# FINAL ENVIRONMENTAL IMPACT REPORT (FEIR) VILLAGE AT PLAYA VISTA

## VOLUME III

2004

Fig. 1 - migration of gas

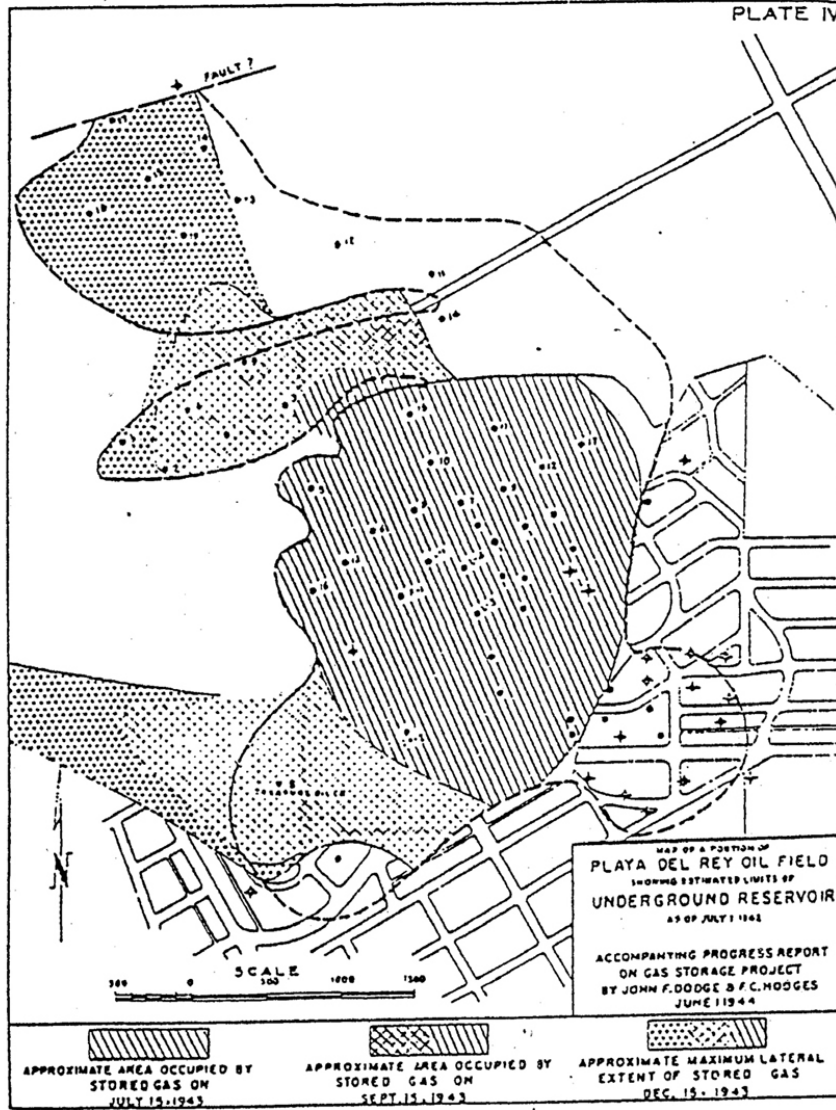
similar systems have not always been successful in other parts of the country in a timely manner to warn of problems.

With regard to the comparison in the comment to the Fairfax area and the need for special construction techniques, please refer to Response to Comment Nos. W-24A.6 and W-24A.7. With regard to gas monitoring, please refer to Response to Comment No. W-18.18.

**FIGURE 2**  
Plot showing wells for area of interest

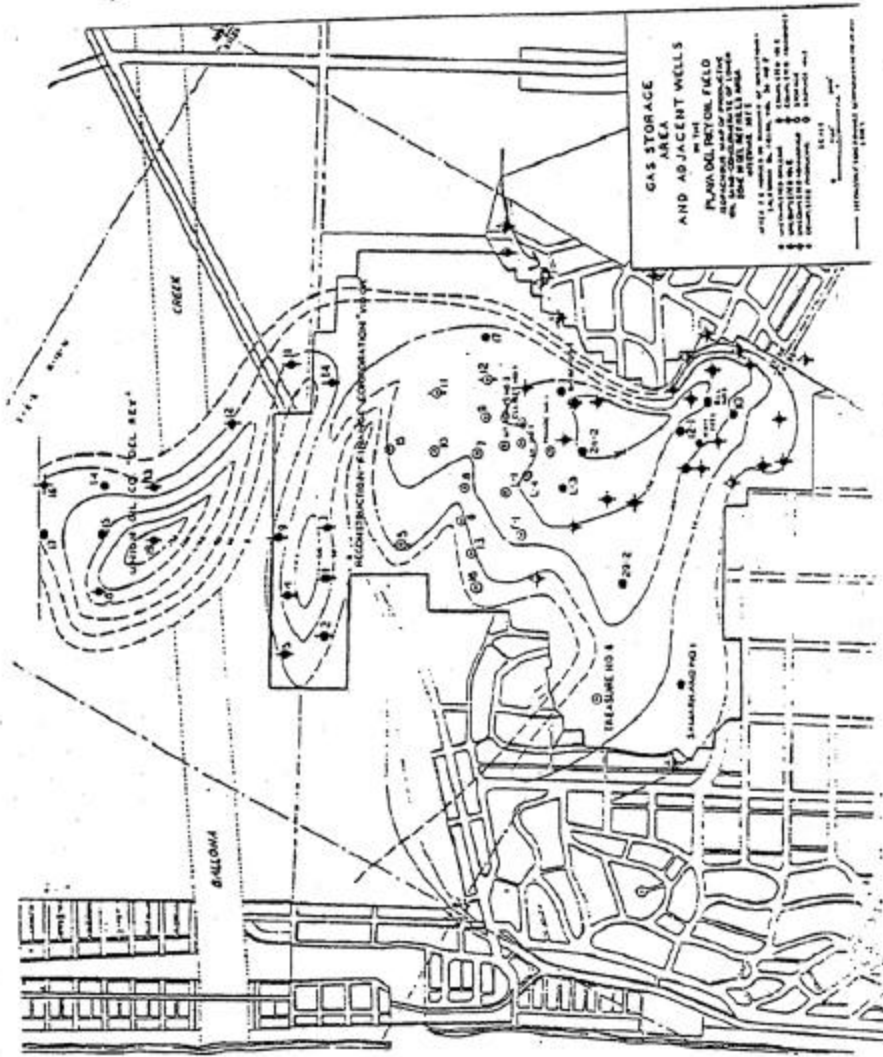
A second potential problem not properly addressed is that some of the figures in the environmental report show only a few of the wells that we have noted on the D.O.G. maps for this area (see Fig.2). As a general policy, no structures should ever be built over abandoned wells. If future problems develop with these wells, such as leaks, there is no way to properly re-abandon the well if a structure is over it. At the very minimum, an area of a 50' radius about the well and access to that area with heavy equipment, should be kept open at all times so that work can be done without removing structures.

No buildings will be constructed within fifty feet of abandoned wells. Figure V.I.3 in the First Phase Draft EIR provided the best available verified information from The Gas Company and as such indicates the location of all known active and abandoned wells on the project site. Please refer to Response to Comment Nos. W-24.6, and W-18.18 regarding building over abandoned wells.

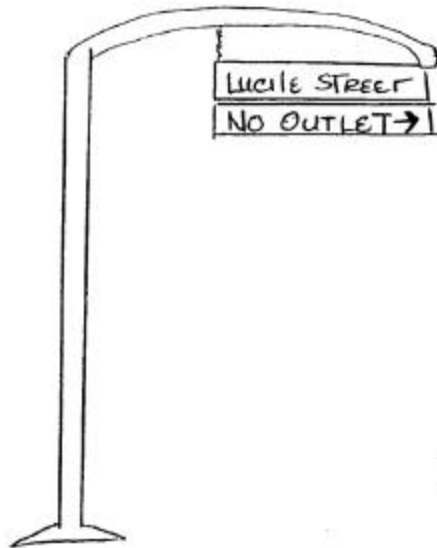
Mr. Shockley's street sign proposals are provided on the following page.

This attachment was submitted in support of comments stated in Comments 189-4 and 189-5. As such comments related to this attachment are addressed in Responses 189-4 and 189-5.
